ADDENDUM NO. 1
PLANS, SPECIFICATIONS AND CONTRACT DOCUMENTS
NOVEMBER 24, 2025

PROJECT: I-16 / I-75 Phase 6 Sanitary Sewer Force Main

OWNER: Macon Water Authority

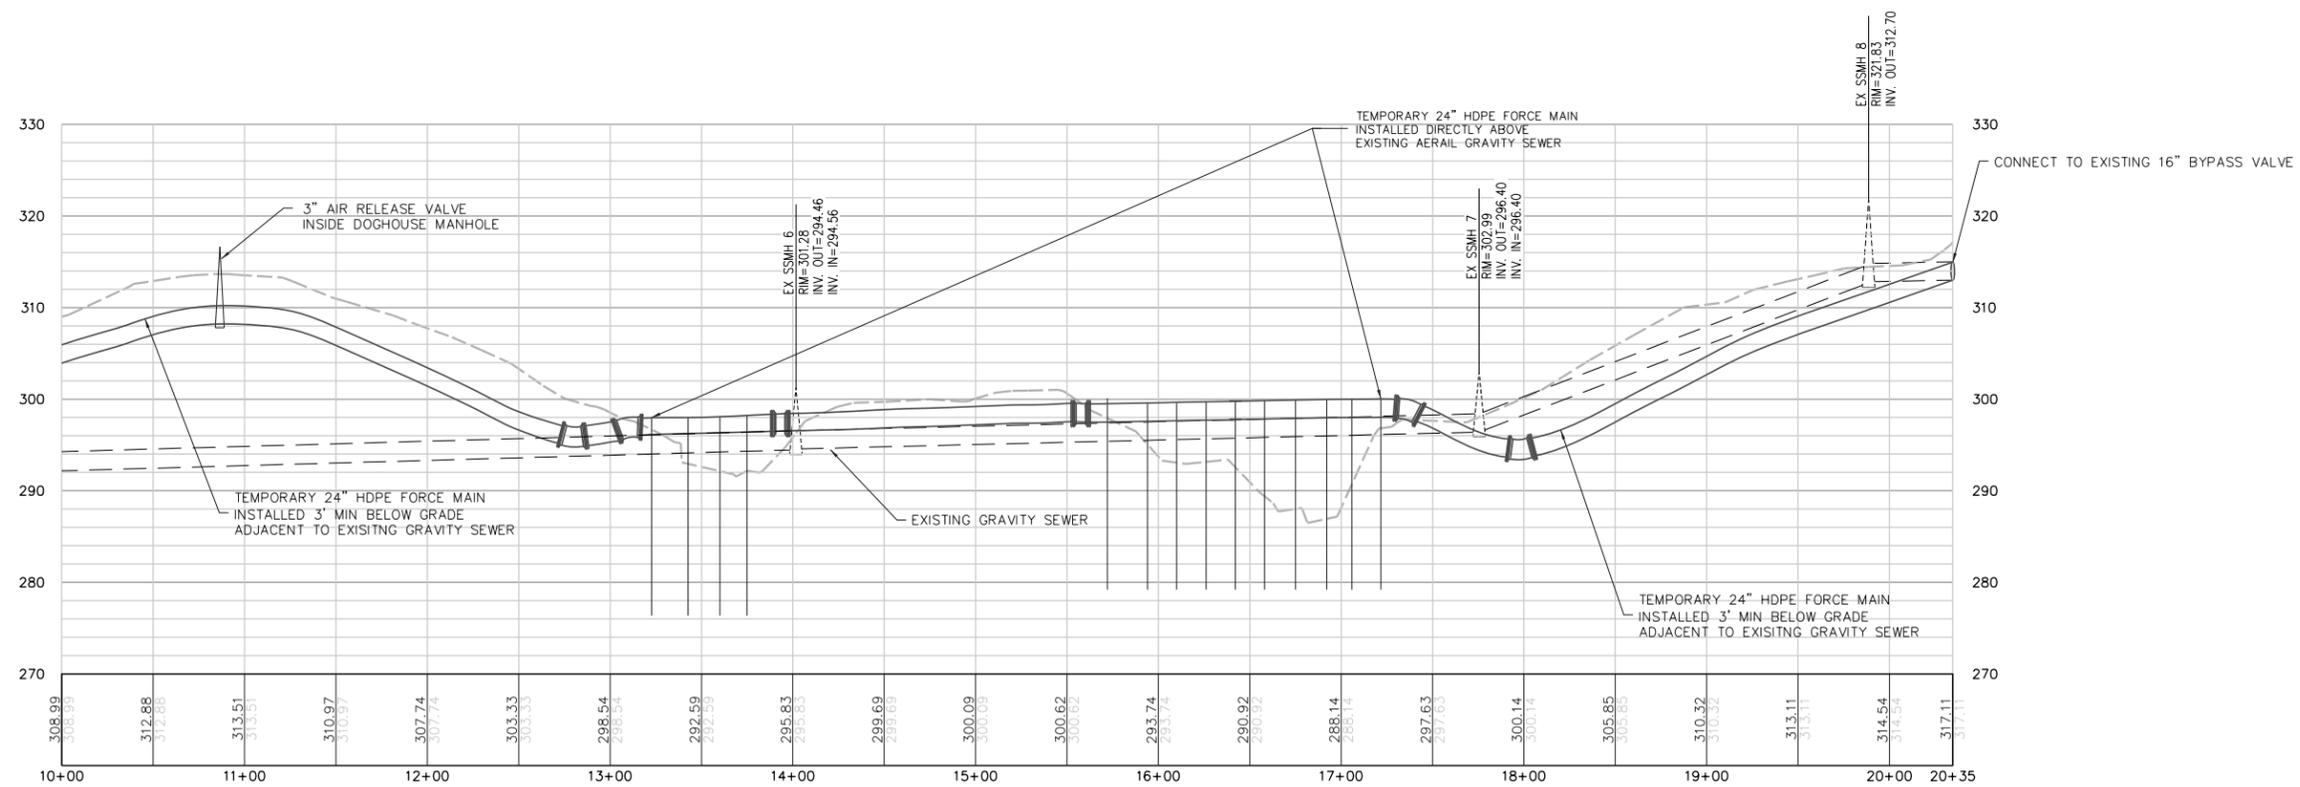
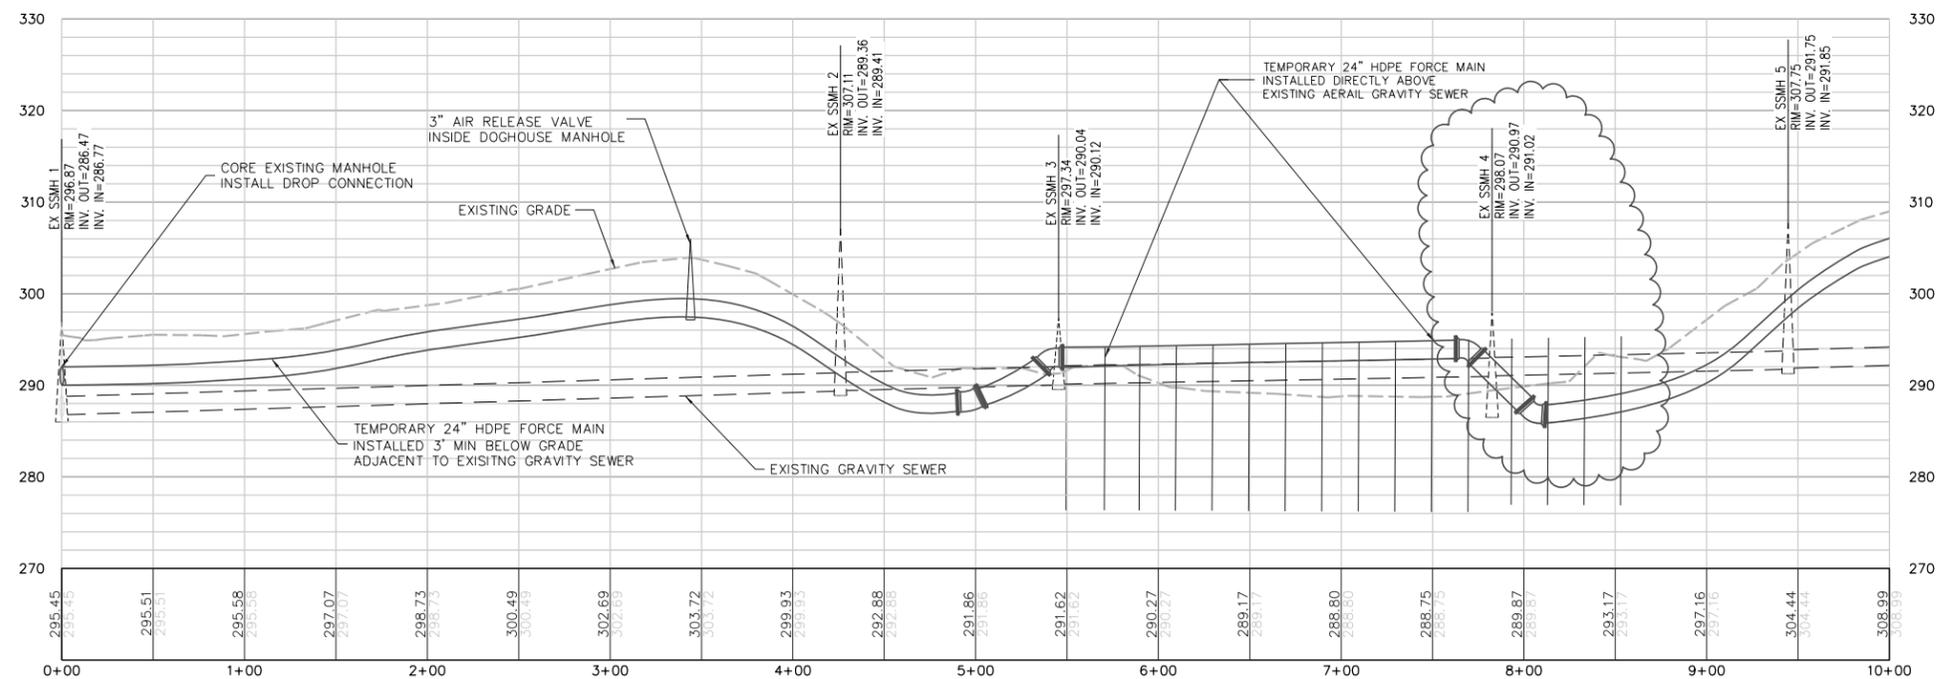
1. The approximate date that the Notice to Proceed will be issued is February 16, 2026.
2. The existing 16" plug valve is installed on the branch line of an existing 16"x16" tee cut in during a previous CIPP project. The new 16" plug valve will be cut in and installed in line with the existing 16" force main between the existing tee and the existing discharge manhole. Attached to this addendum is diagram of the proposed plug valve installation and a picture of the existing tee and plug valve while they were being installed in the previous project.
3. *Section 00700 – General Conditions, Article 30, paragraph (d) Materials stored.* outlines the conditions that must be met to receive payment for stored materials.
4. A link to the Corbin Avenue 12-month flow data is included in the attachments to this document:
5. The Corbin Avenue Pump Station can not be throttled.

DRAWING No.
C05

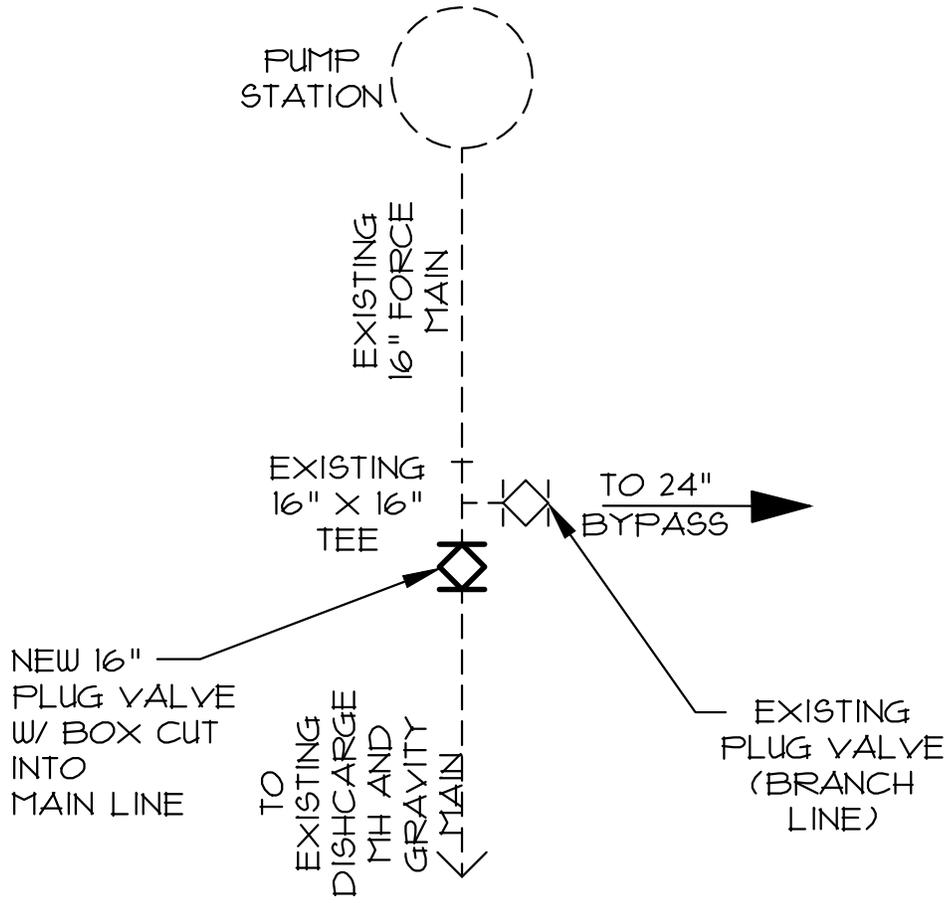
Plan Sheet C05 to be replaced with the plan sheet bearing the revision date of 11/11/2025. The plan sheet reflects a pipeline vertical alignment change at EX SSMH 4
